Amendment No. 0002
30 December 2003

SUBJECT: Amendment No. 0002 to Request for Proposal Solicitation Package
for Design and Construction of REPLACE CENTRAL FIRE ALARM SYSTEM, PN 3378,
IOWA AAP, IOWA.

Solicitation No. DACA45 03 R 0034.

SKETCH SKF4.06
BLDG 3A-04 Floor Plan

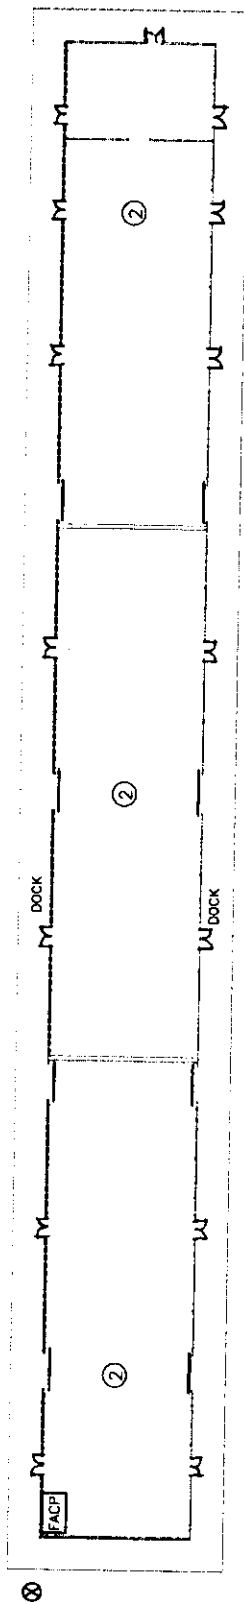
(1) Sheet F4.06, BLDG 3A-04 floor plan, revise floor plan to show door openings and floor plan revisions in accordance with attached Sketch SKF4.06.

SKETCH SKF4.08
BLDG 3A-01 Floor Plan

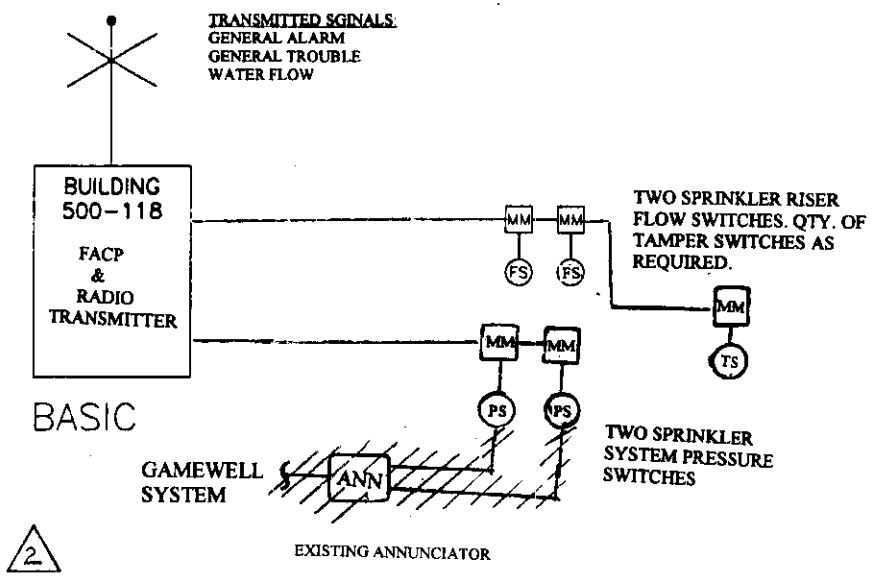
(b) BLDG 3A-01 floor plan, revise floor plan to show door openings in accordance with attached Sketch SKF4.08 and add the following note:

"NOTE: THE FACP SHOWN MAY BE LOCATED OUTSIDE THE BUILDING OR INSIDE THE BUILDING WITH A PROPERLY RATED ENCLOSURE."
